Delegated Report

Householder Planning Application

Planning Application No: 20220361

Location: Valley Side 53 Rhododendron Avenue Meopham Gravesend

*Refused Application (Ref. 20220040)
Proposed Front Elevation*

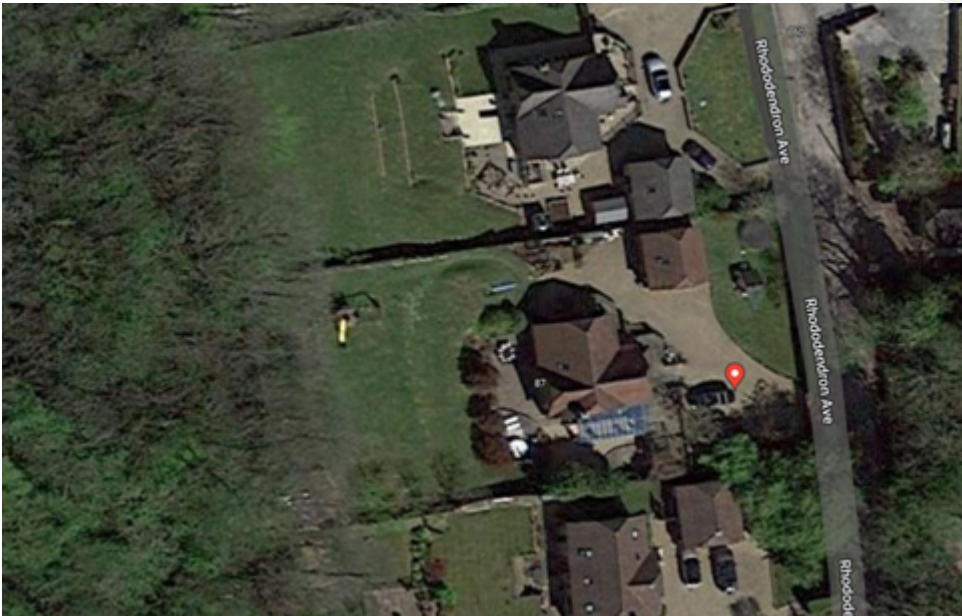
This current application is a resubmission of planning application 20220040 for the *erection of a single storey side extension, demolition of an existing rear gable end and erection of a rear dormer*, which was refused for the following reason;

1. The proposed side extension and rear dormer, by virtue of the design and relationship to the host dwelling, would harm the character and appearance of the application building and the character of the area. The proposal would result in an overall incongruous design which would fail to comply with the requirements of Policy CS19 of the Gravesham Local Plan Core Strategy 2014, and paragraphs 126 and 130 of the National Planning Policy Framework 2021.

The following images highlight the differences between the previous and current applications:

Overall, it is considered that the current proposal has addressed the previous reason or refusal.

Proposed Front Elevation

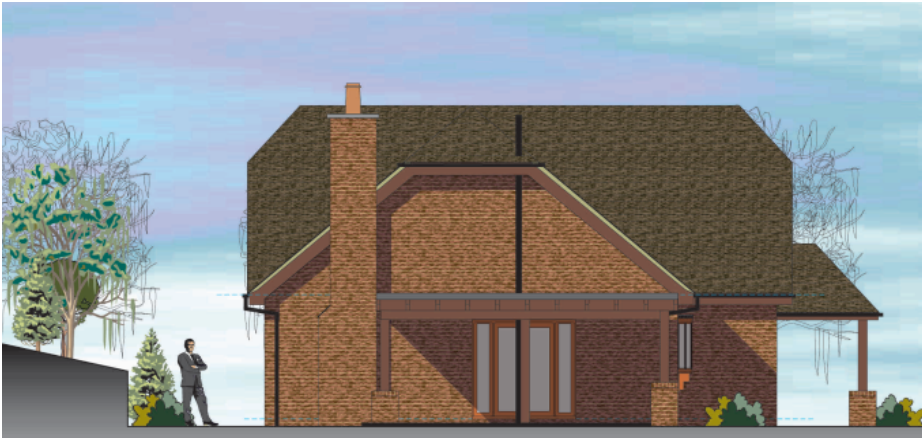
The original dwelling is a modest well-designed chalet style bungalow. The proposed side extension would replace the canopy to the side. The proposed single storey side extension would project approx. 4.84m from the existing principle side elevation and would be set back from the principle front elevation by 2.1m. The ridge height of 5.8m would be set lower than the host dwelling by 700mm and would have a gable end to the front and rear with full height glazing. The roof would be pitch on both sides with 4no. roof lights on the south facing roofslope and would join the side elevation or barn hip roof of the existing dwelling with a small pitch. It would also be constructed with facing brick and roof tiles to match the host dwelling. Paragraph 10.4 of the Householder Extensions/Alterations Design Guide (2021) states that extensions should generally aim to appear subservient to the original building by lying behind the main front building line and should be no greater than half the width of the original building. It should also incorporate roof designs to reflect the main property's roof, as well as matching external materials.

The proposed front and rear dormers are both single with a gable style and would respect the host dwelling and therefore there is no objection in this regard. Paragraph 10.9 of the Householder Extensions/Alterations Design Guide (2021) states that rear dormers should be lower than the existing ridge-line and should not overwhelm the roofslope. Paragraph 10.10 states that front dormers are generally not acceptable where there is not an existing established character within the immediate surrounding streetscene. The majority of the properties on Rhododendron Avenue vary significantly in design and the proposed front dormer is both modest and well designed.

Whilst the proposed extensions are slightly outside the one third limit increase over the original dwelling, it is only marginally and overall they have been designed to reflect the existing dwelling and incorporate features of the original property and are considered to be subservient to the original build.

The proposed extension and front and rear dormers are acceptable additions to the existing dwelling that would respect the property and the development is therefore in accordance with Policy CS19 of the Local Plan Core Strategy and the Householder Extensions/Alterations Design Guide (2021).
